Proposed Changes for SPI-4

00-246r5

Paul Aloisi TI

The driver/receiver electrical changes proposed for SPI-4

Figure 49 Paced Timing diagram and the paragraph under the figure TBDs replaced a table expect for the free running clock which is 100 mV.

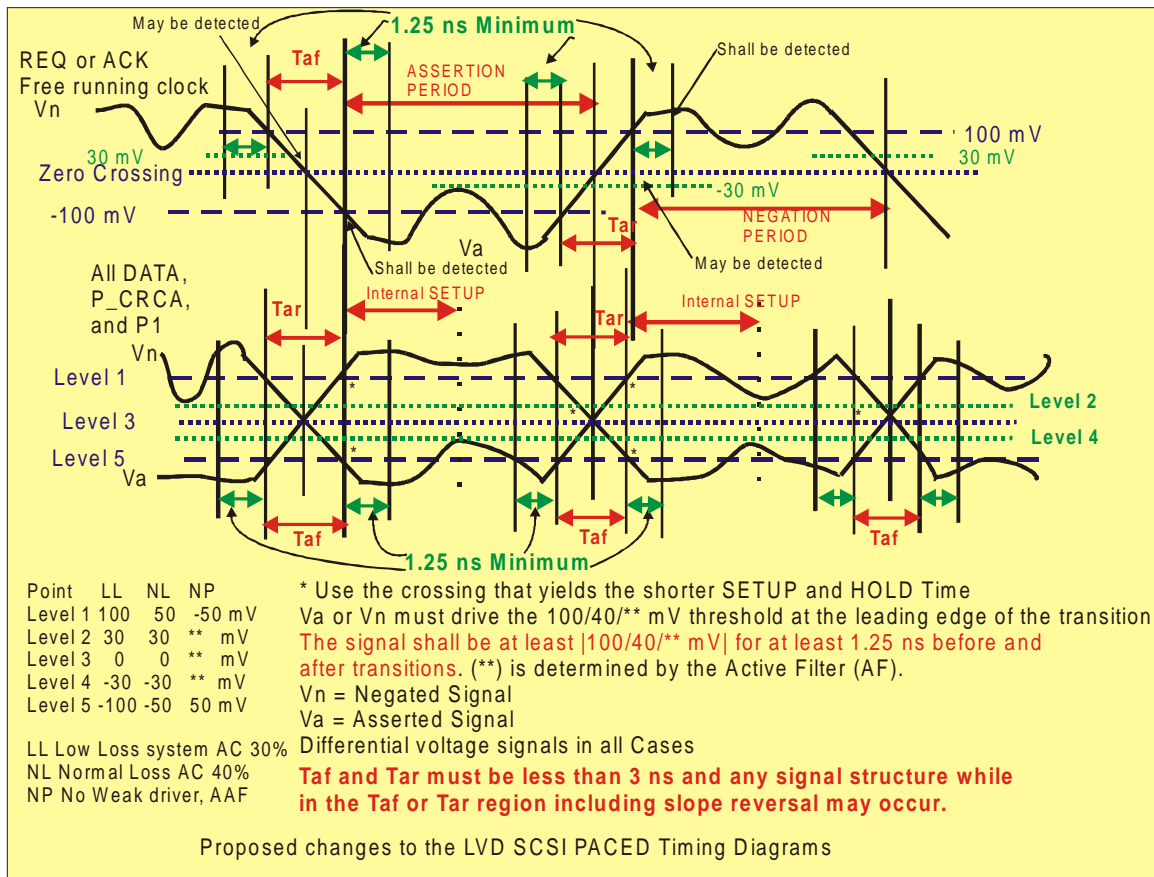
Low Loss (LL)

The signal shall transition for LL (low loss systems) from -100 to +100 mV or +100 to -100 mV in 0 to 3 ns, the waveform between -100 and +100 mV is not otherwise specified. The absolute value of the signals shall remain above the 100 mV level for 1,25 ns at each end of the transition. The absolute value of the signals shall not drop below 30 mV except during the transitions (see 7.3.2).

Normal Loss (NL)

The Free running clock shall transition for NL (normal loss systems) from -100 to +100 mV or +100 to -100 mV in 0 to 3 ns, the waveform between -100 and +100 mV is not otherwise

specified. The other signals, the first transition from the multiple bit level shall transition -100 to $+50$ mV or $+100$ mV to -50 mV, if there is an immediate transition the $+50$ mV to -100 mV or -50 mV to $+100$ mV. The absolute value of the signals shall remain above the 100 mV multiple bits or 50 mV for a single bit level for $1,25$ ns at each end of the transition. The absolute value of the signals shall not drop below 30 mV except during the transitions (see 7.3.2).

Weak driver off / AAF Adaptive Active Filter (NP)

The Free running clock shall transition for NP (no weak driver systems) from -100 to $+100$ mV or $+100$ to -100 mV in 0 to 3 ns, the waveform between -100 and $+100$ mV is not otherwise specified. The other signals, the first transition from a multiple bit level shall transition at least 150 mV and shall be a minimum 50 mV from the zero crossing, example -200 mV level shall transition to -50 mV for a valid transition.

The absolute value of the multiple bit signals shall remain above the 100 mV for $1,25$ ns at each end of the transition. The absolute value of the signals shall not drop below 30 mV except during the transitions (see 7.3.2).

Fast-160 Receiver Mask NP, during the data transitions
 +/-1.1 volt maximum with reflections

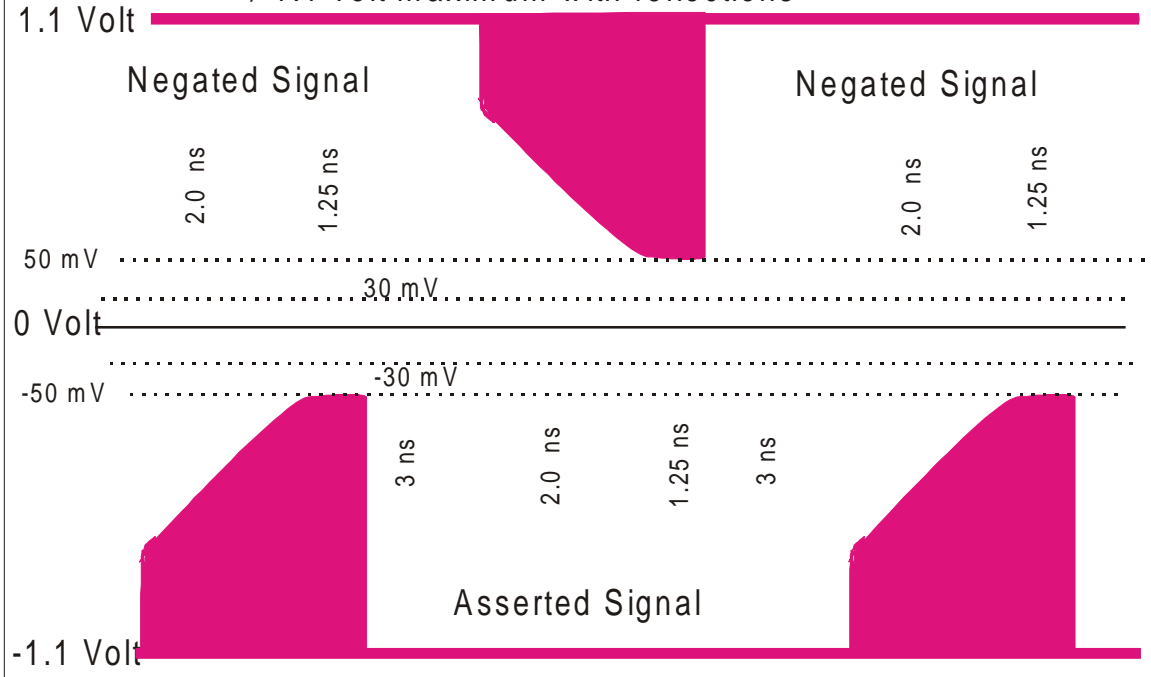
The ratio of the Peak before the transition to the Peak at the end of the next bit time in the 1.25 ns range shall transition 150 mV minimum.

Not Allowed
